SERVICE BULLETIN

NON MODIFICATION SERVICE BULLETIN — ENGINE — LP COMPRESSOR —
INTRODUCTION OF A NEW FRONT MOUNT TUBE STOPPER

V2500 Series 72-0669

V2500-ENG-72-0669

LOCATION OF FRONT MOUNT TUBE STOPPER
72-32-03
FIGURE 1

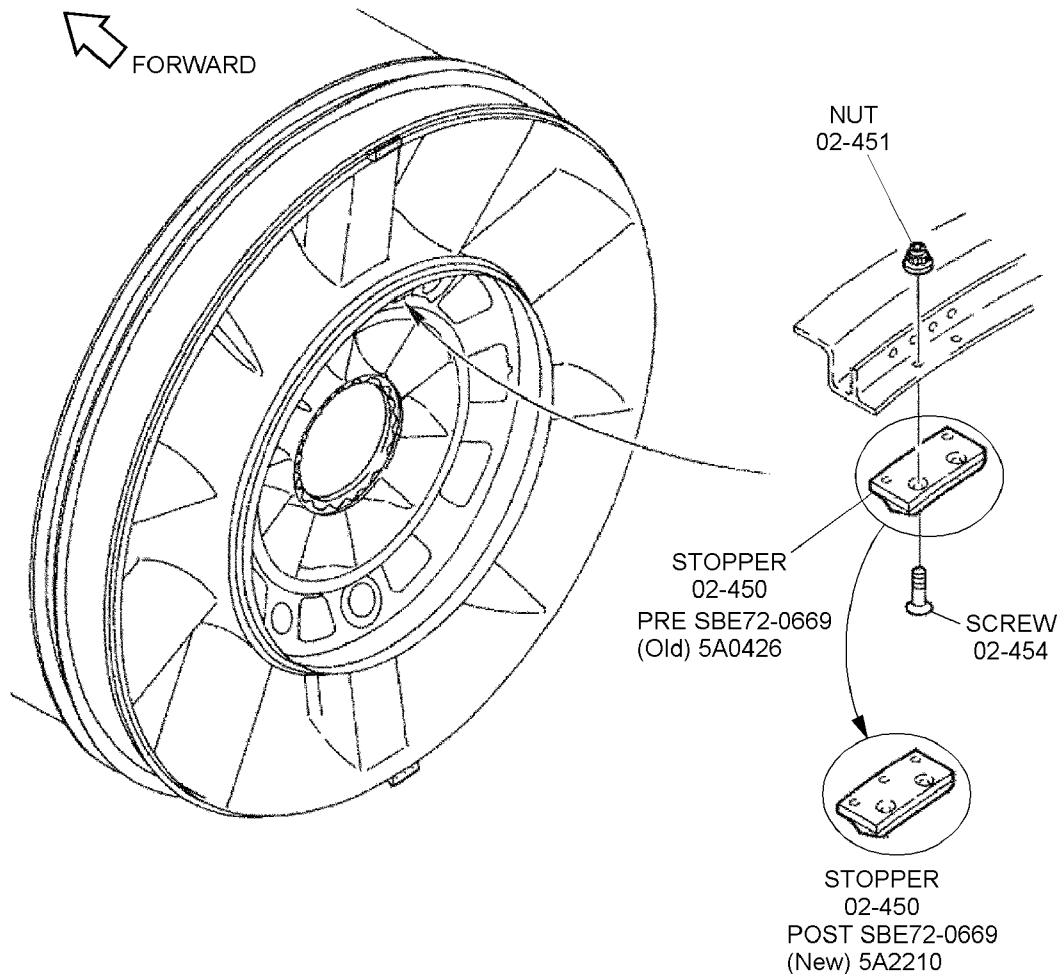
The front mount tube stopper is changed to a new stopper with improved durability.

1. Assembly Instructions for engines installed on the aircraft (on-wing)
 - A. Install the Front Mount Tube Stopper, PN 5A2210 in accordance with Reference 6, Aircraft Maintenance Manual Chapter/Section 72-32-03 Installation. See Figure 1.
2. Assembly Instructions for engines removed from the aircraft (in-shop)
 - A. Install the Front Mount Tube Stopper, PN 5A2210 in accordance with Reference 4, Engine Manual, Chapter/Section 72-32-00, Assembly-14. See Figure 1.
3. Recording Instructions
 - A. A record of accomplishment is required.
